Final Remedial Construction Report AOC 3

**Iron Horse Park Superfund Site
Operable Unit 3, Billerica, MA**

19 November 2020

On behalf of Pan Am Railways (Pan Am), Environmental Resources Management (ERM) is submitting a field revision to the AOC 3 landfill design presented in the approved AOCs 1, 2, and 3 Final Design Report, and dated 24 September 2012. This revision is prompted from encountering refusal at a shallower depth while driving sheet pile in a localized segment in AOC 3A. Specifically, this modification is requested for AOC 3A for the following:

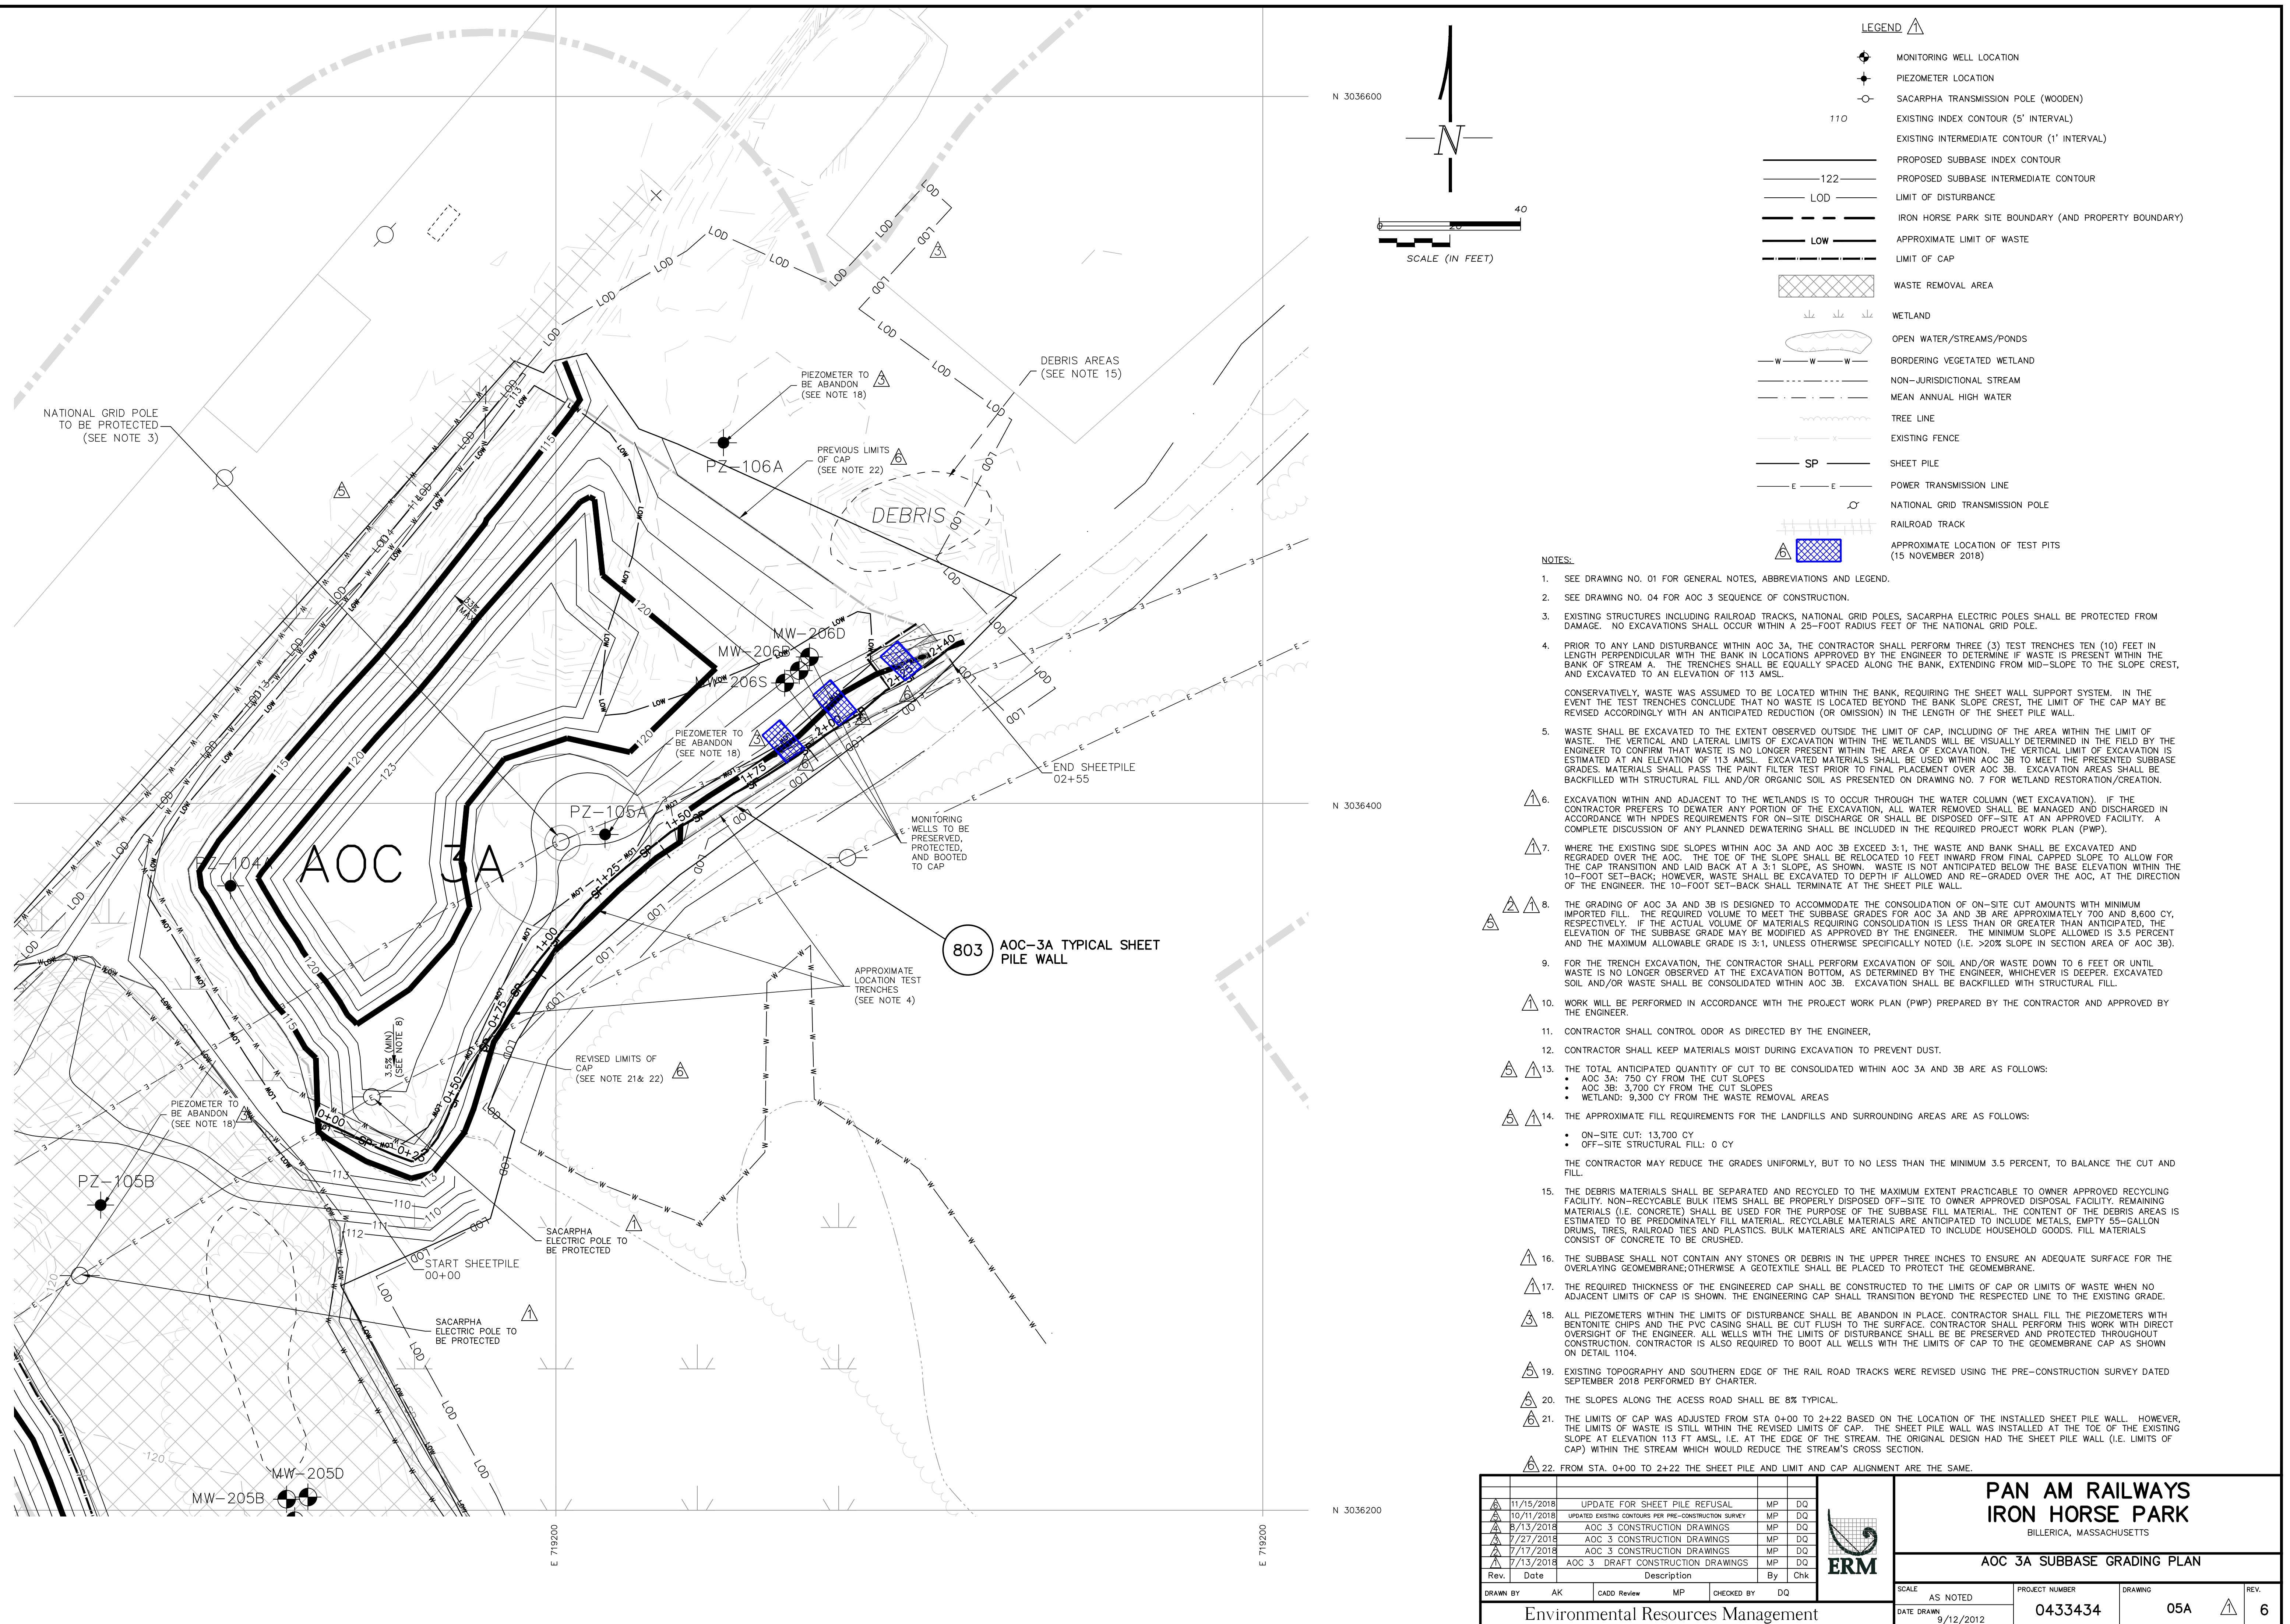
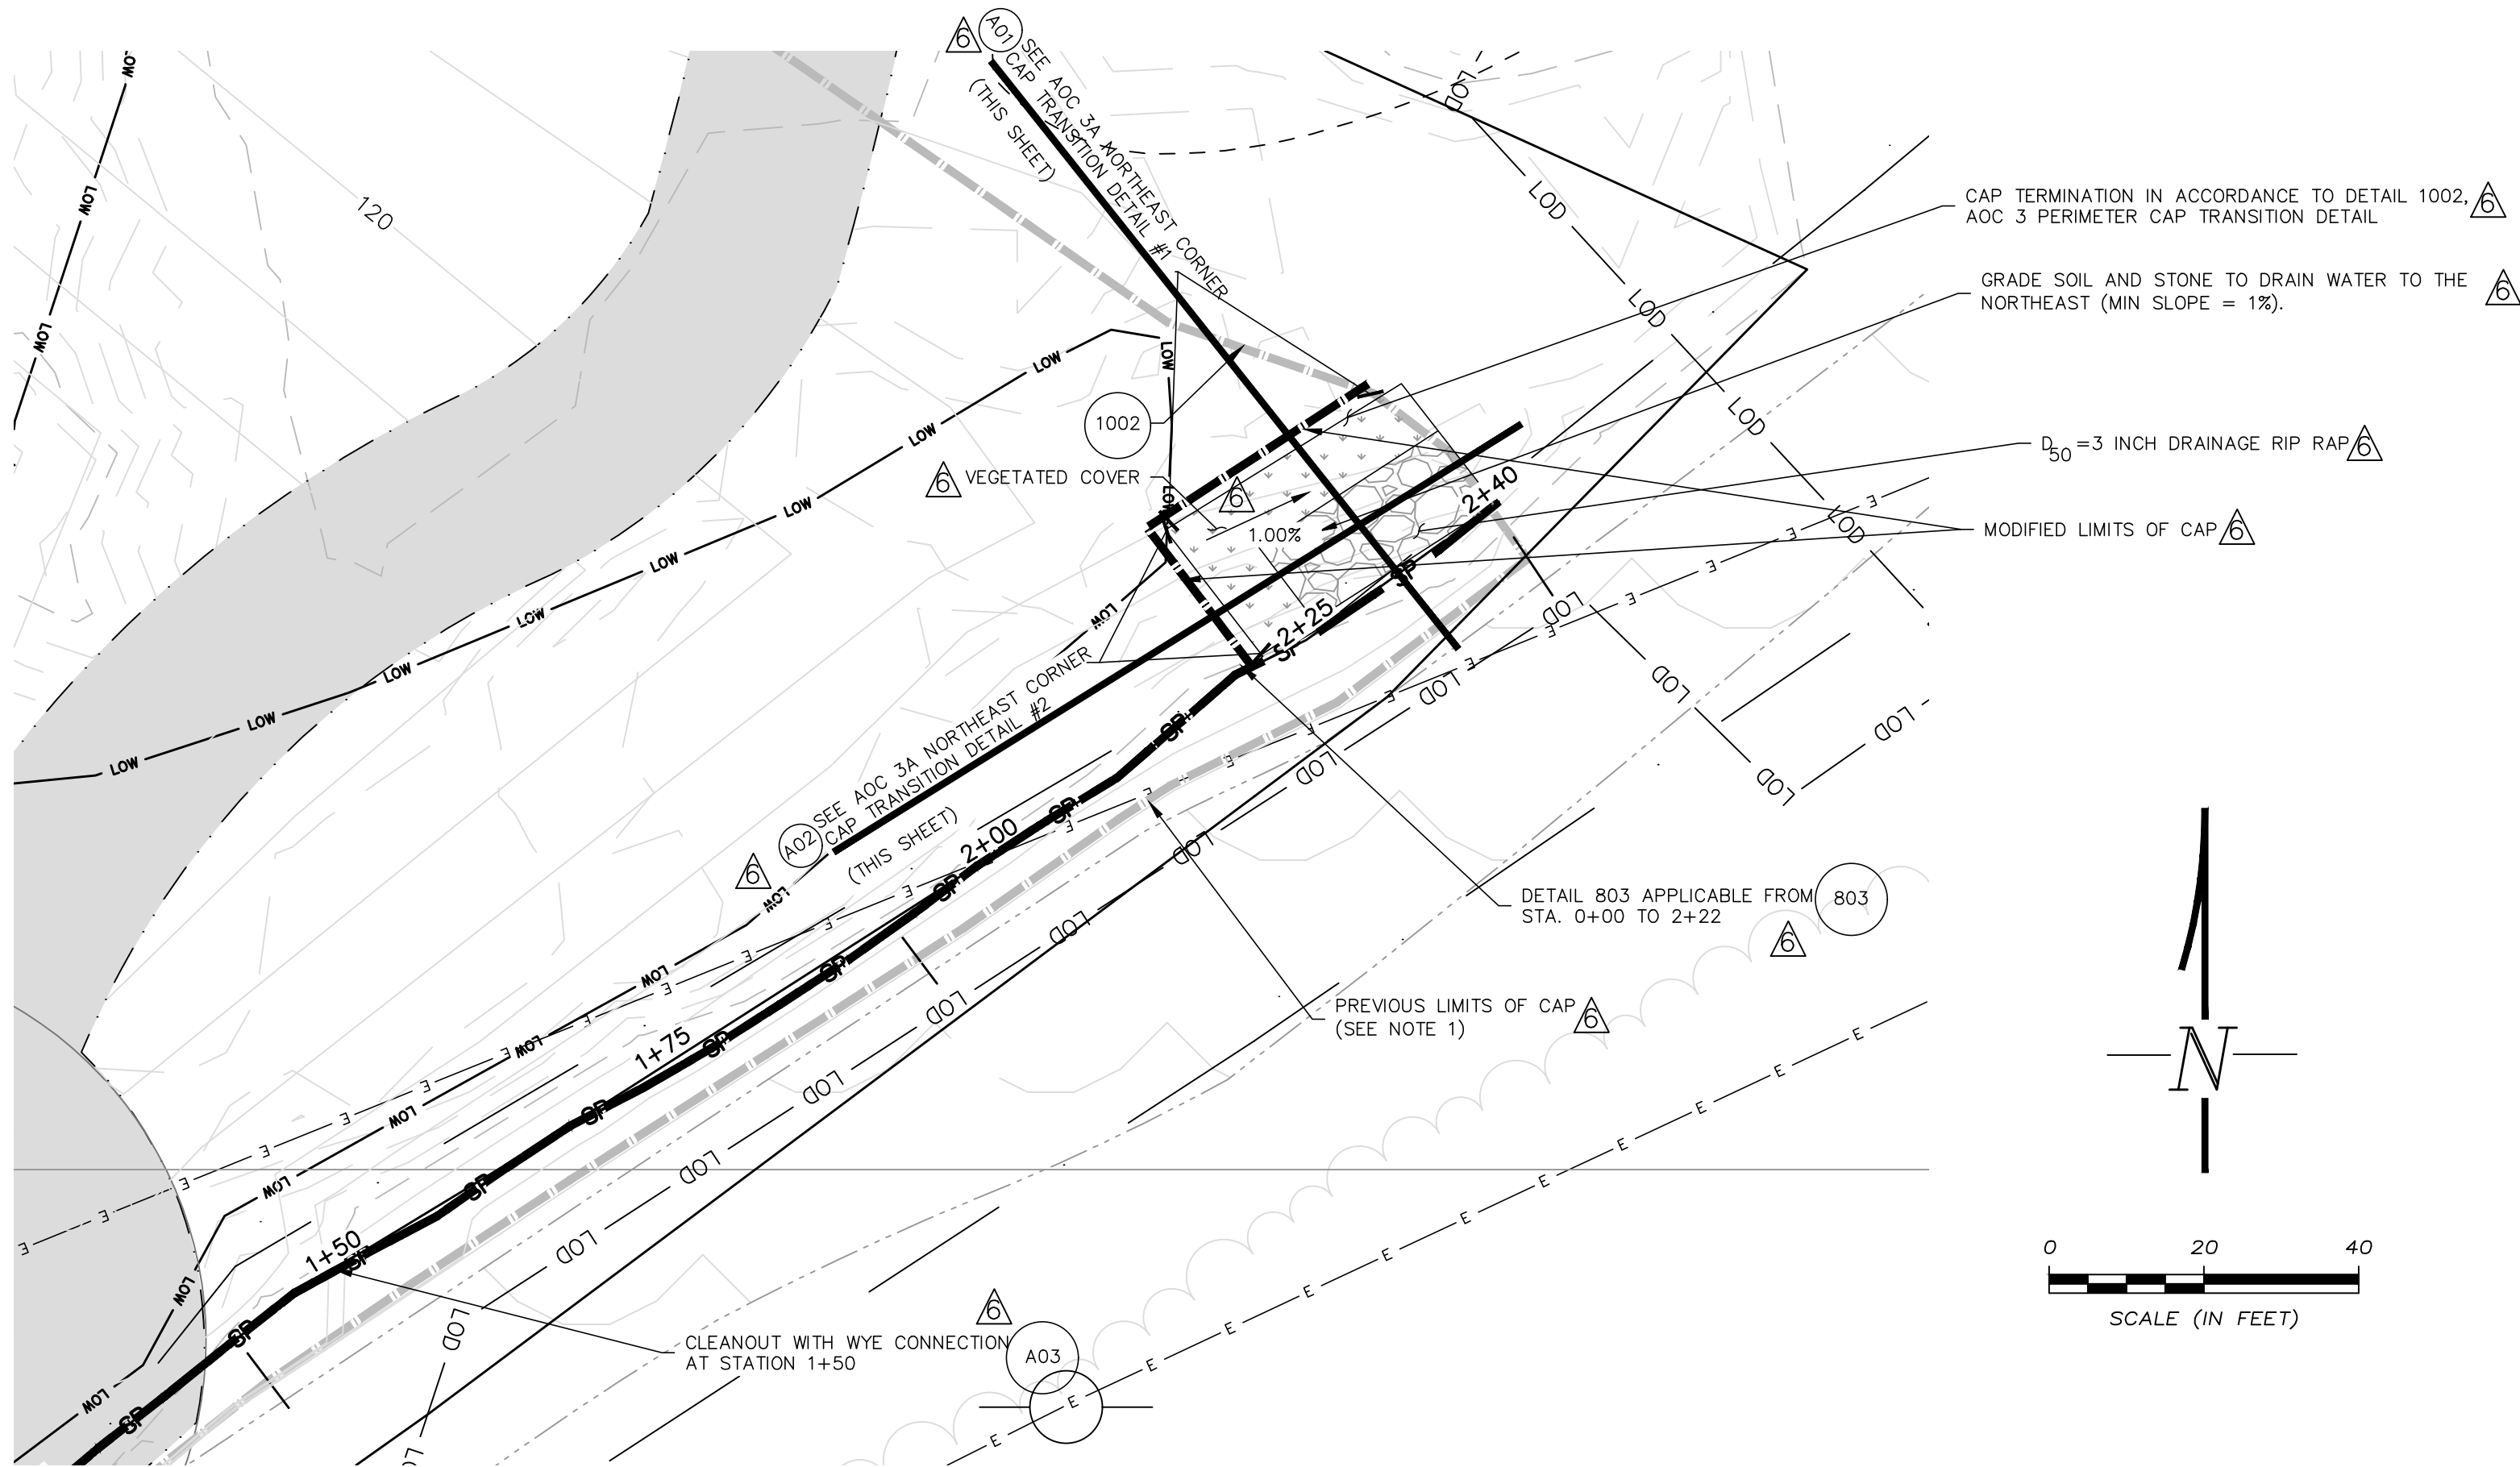
1. An adjustment to the final height of the steel sheet pile from sta 0+95 to sta 1+55 (height changed from 119 to 117)
2. An adjustment to the final height of the steel sheet pile because of encountered obstructions during installation between sta 2+27 and sta 2+40. The cap system will daylight to stone in this area (not be mechanically connected to the wall); and
3. Minor adjustment to the limits of cap and the cap transition to the wall.

An adjustment of the height of the sheet pile in this area is necessary to accommodate field conditions. The final height of the sheet pile would be adjusted from elevation 119 to elevation 117. Updated calculations for this revision were unnecessary as the stick up (cantilever) was reduced.

A field revision is proposed to adjust the steel sheet pile embedment depth, cantilever height, and cap fill against the wall. This is necessary as

In order to accommodate the pipe daylighting, the cap limits have been nominally adjusted such that the limits of cap are approximately 10 feet back from the sheet pile wall (from stations 2+22 to 2+40). This is possible as the test pits excavated on 15 November 2018 did not identify waste in this area (see Attachment B for photo log). Consequently, the limits of waste were observed at approximately 15 feet from the location of the wall shown in Drawing 05A, thereby, allowing the limits of cap to be revised. Therefore all waste identified in this area will be covered by the cap. The approximate locations of the test pits are shown in Drawing 05A.

In addition to the area of refusal, the sheet pile wall was slightly adjusted inward along the entire stream bank. This was necessary to allow the sheet pile to be installed at the toe of the existing slope (instead of within the stream itself). However, the limits of cap remains outside of the limits of waste (*e.g.*, all waste identified in this area is still covered by the cap).

The cap will terminate in this area in accordance with detail A01 and A02 from design drawing A. The area between the cap termination and the steel sheet pile wall will be stone covered to promote drainage and minimize erosion.

AOC 3A SHEET PILE WALL PROFILE

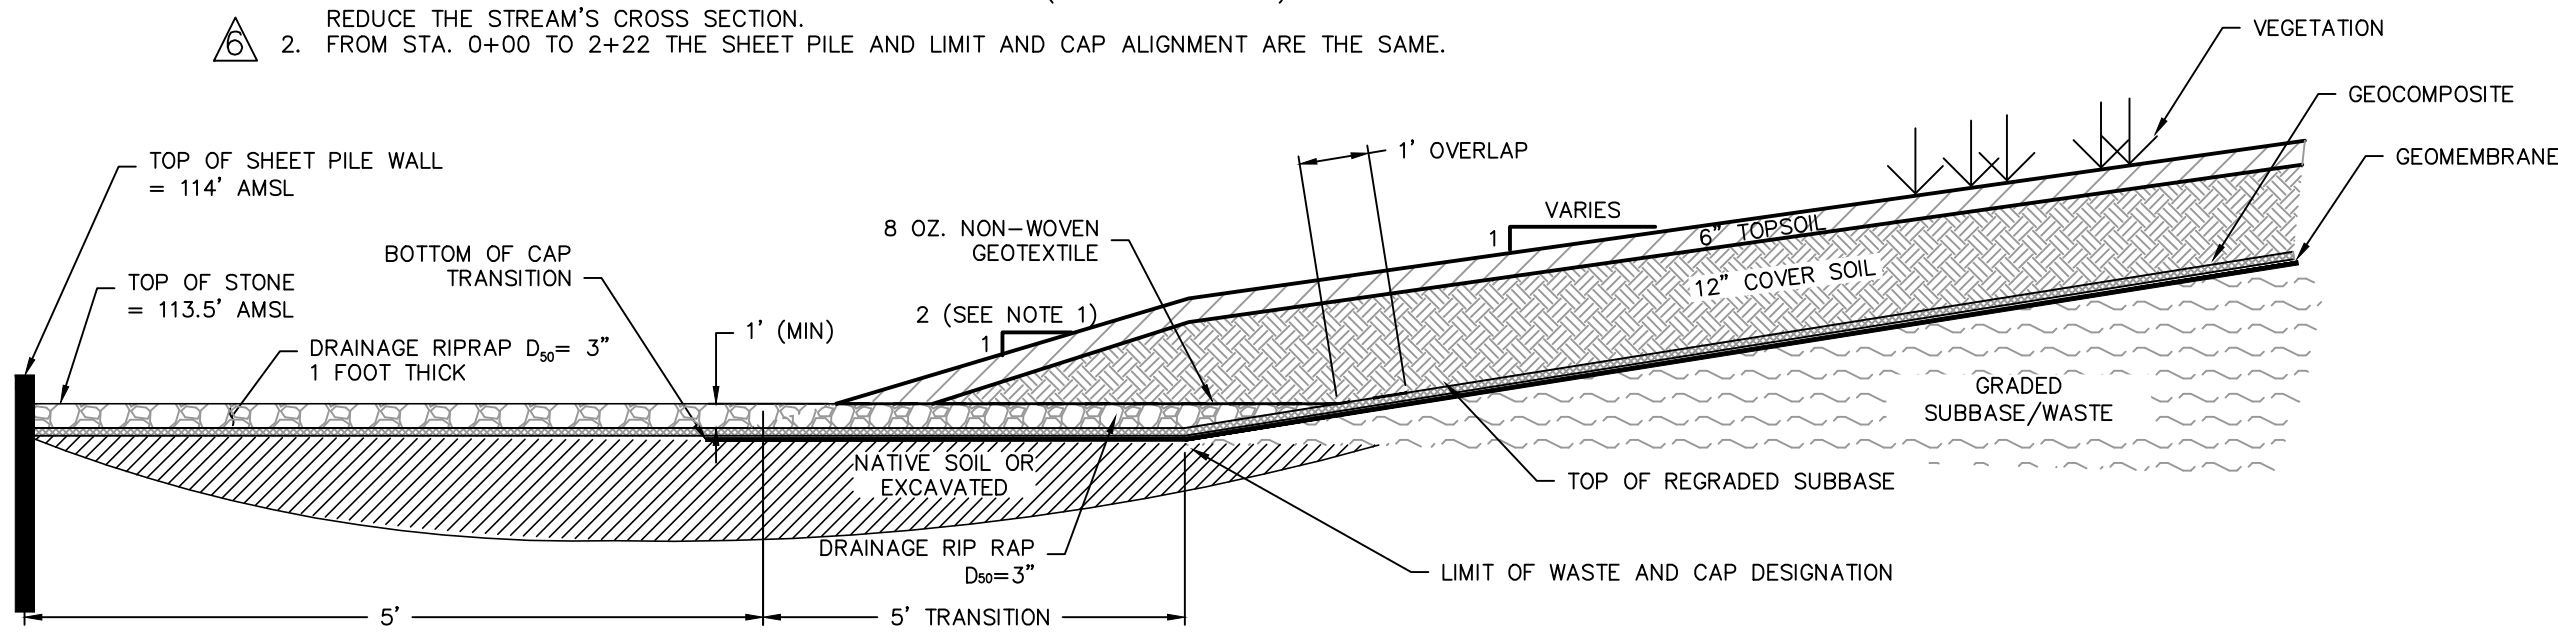
- NOTE:
1. THE LIMITS OF CAP WAS ADJUSTED FROM STA. 0+00 TO 2+22 BASED ON THE LOCATION OF THE INSTALLED SHEET PILE WALL. HOWEVER, THE LIMITS OF WASTE IS STILL WITHIN THE REVISED LIMITS OF CAP. THE SHEET PILE WALL WAS INSTALLED AT THE TOE OF THE EXISTING SLOPE AT ELEVATION 113 FT AMSL, I.E. AT THE EDGE OF THE STREAM. THE ORIGINAL DESIGN HAD THE SHEET PILE WALL (I.E. LIMITS OF CAP) WITHIN THE STREAM WHICH WOULD REDUCE THE STREAM'S CROSS SECTION.
 2. FROM STA. 0+00 TO 2+22 THE SHEET PILE AND LIMIT AND CAP ALIGNMENT ARE THE SAME.
